Appl. No.: 10/709,679
Amdt. Dated: 7/6/2005
Reply to Office action of: 05/09/2005

AMENDMENTSTOTHEDRAWINGS:

REMARKS/ARGUMENTS

Fig. 3

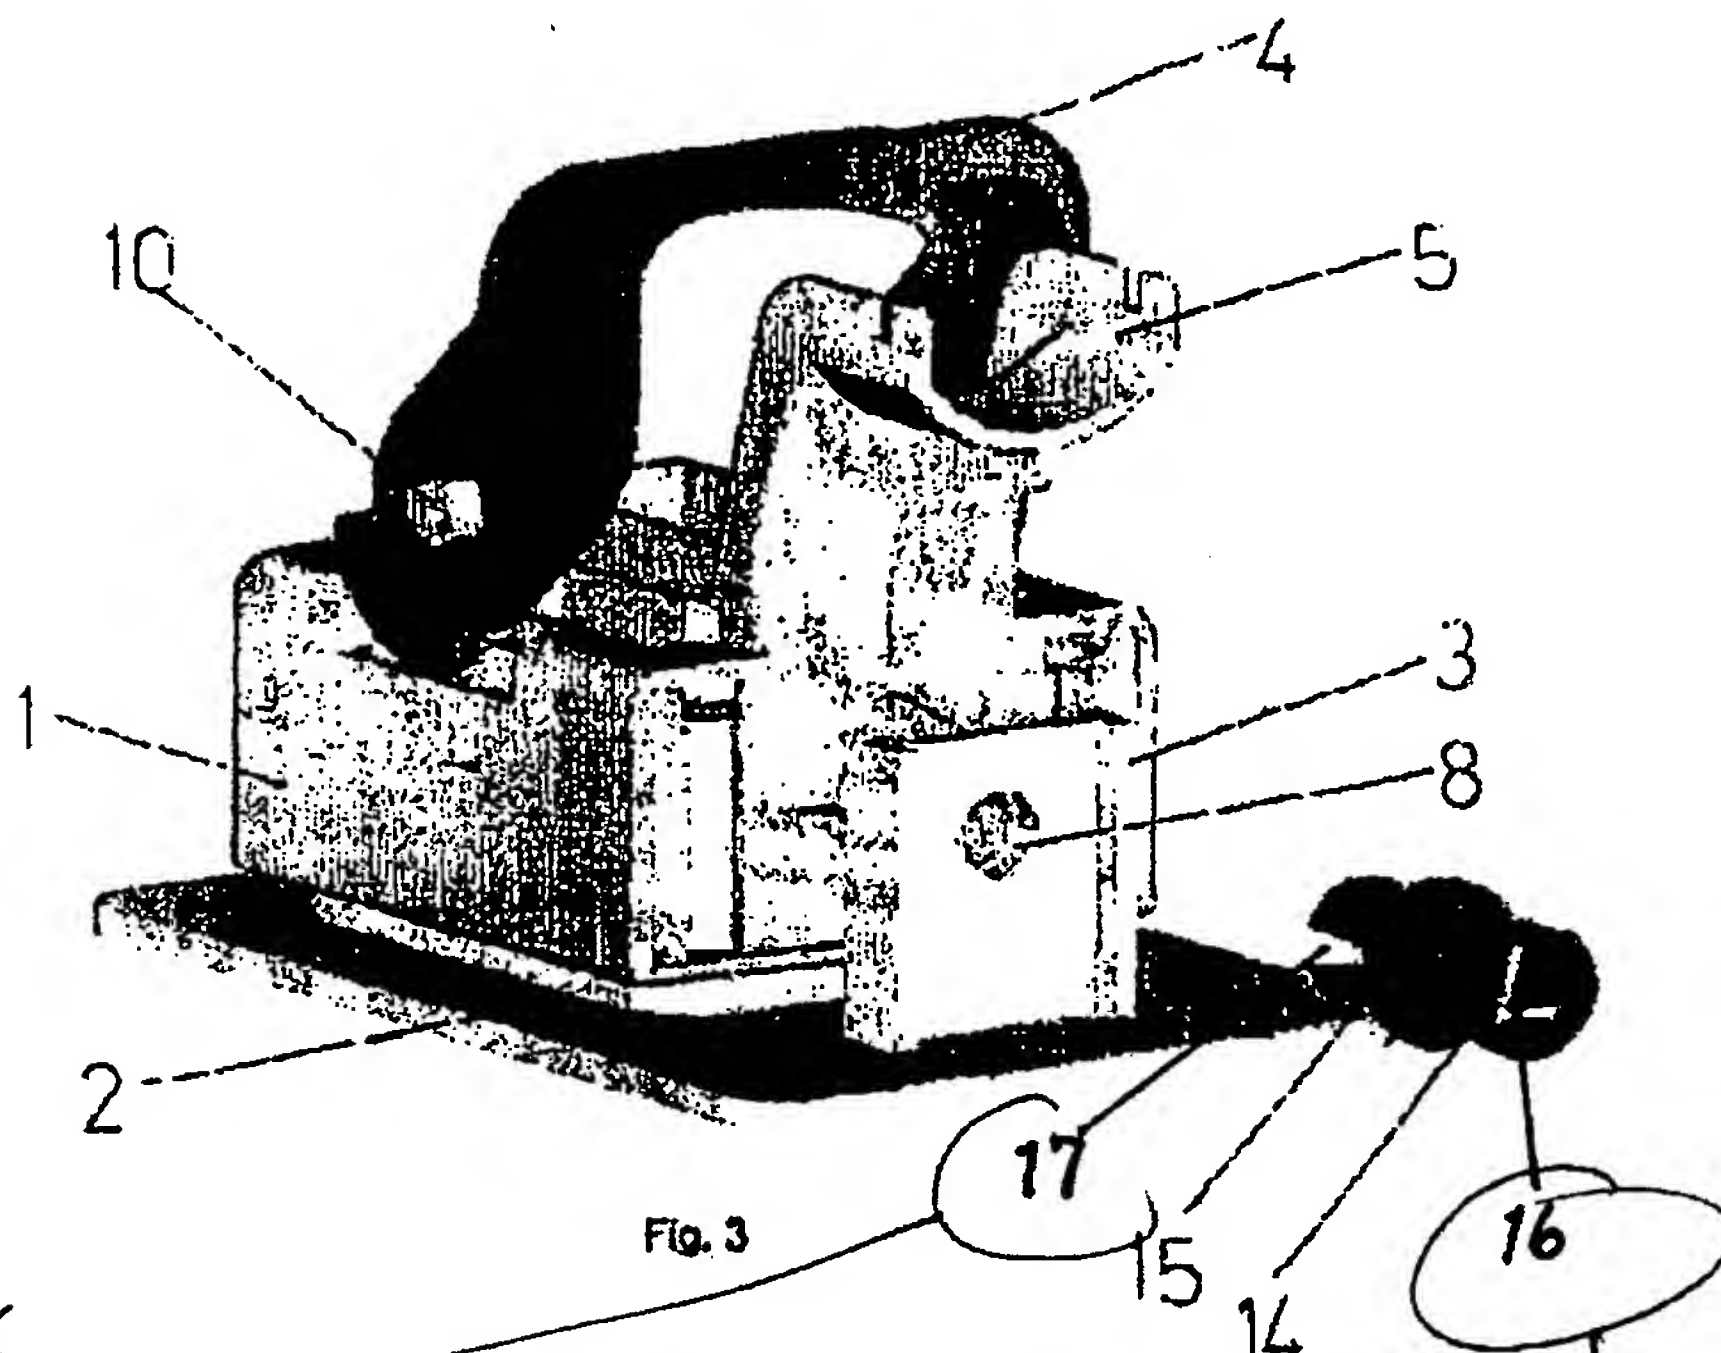
Amended Figures 3 and 4 label the non-universal screw head slot and the sidewall opening in the trunco-conical part.

Element
17 Added

The attached sheet(s) of drawings includes amended Figures 3 and 4 having two omitted numbers added to identify clearly two of the elements shown therein, and new Figures 5 and 6.

Fig. 4

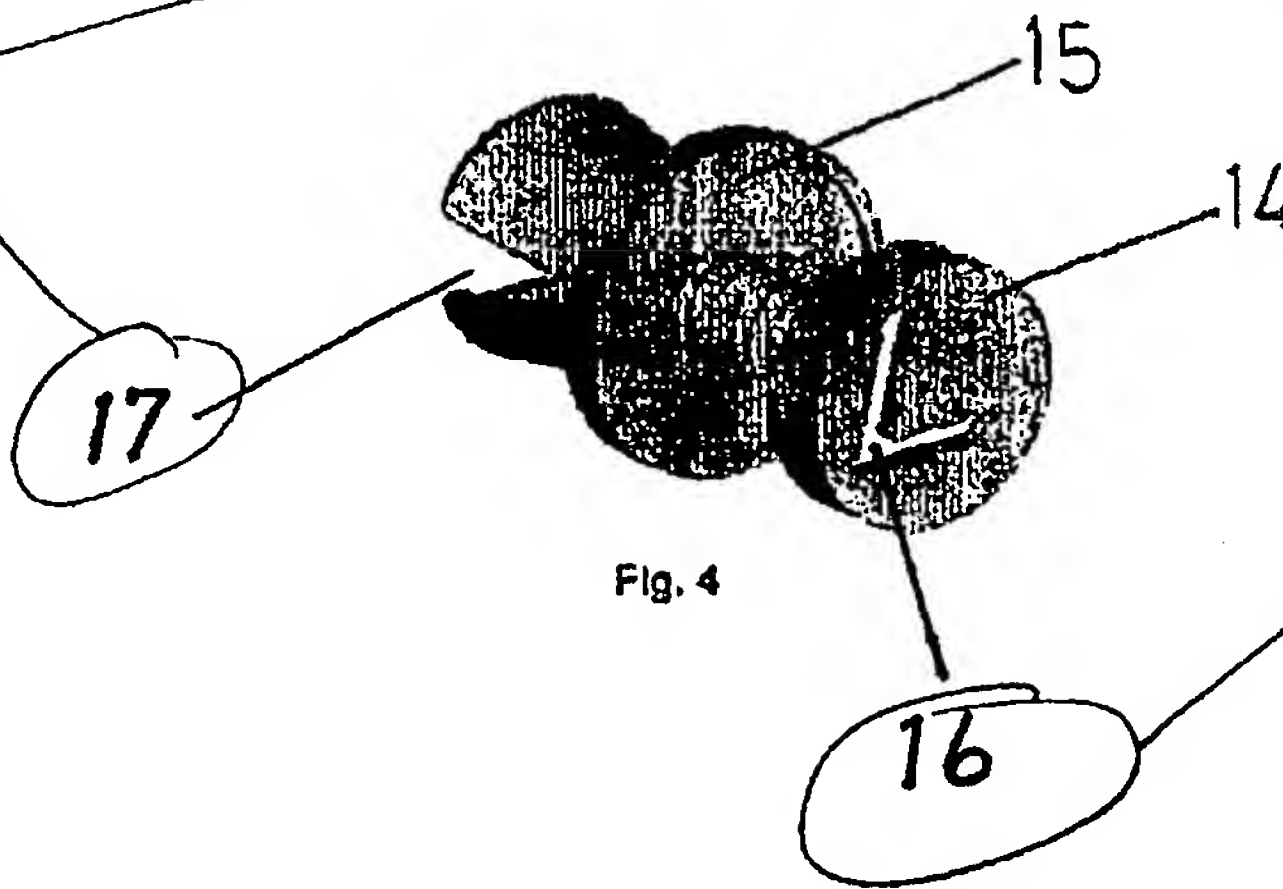
Therefore, the screw with a hollow truncated-conical part partially introduced therein and a non-universal configuration must be shown or the feature(s) canceled from the claims 1 – 2. No new matter should be entered.

...because they fail to show the screw provided with a partially introduced hollow-conical part, its open ends and the side opening in the wall as well as a particular head as described in the specification.

Evidence that claims fail to correspond in scope with that which applicant(s) regard a the invention can be found in the Figure 4 which shows a screw 14 partially introduce in a trunco-conical part (not numbered). This indicates that the invention is different from what is defined in the claim(s) because the claim suggests the part 15 is partially introduced in the screw.

Note: A screw 14 with a universal head and partially introduced in a trunco-conical part (not numbered) has been assumed.

Applicant has amended original Figure 4 to identify the non-universal screw head slot (17) inadvertently not labeled, and has amended the specification to more clearly

describe this non-universal screw head slot (17) shown in original Figure 4. In addition, the specification has been amended to describe more clearly the mounting of screw (14) in anchor body (15) as also originally shown in original Figure 4. The confusion in the description of mounting the screw (14) in the anchor body (15), pointed out by the Examiner having arisen from an error in translation. Therefore, Applicant believes that this objection has now been rendered moot and requests that it be removed.

Element 16
Added
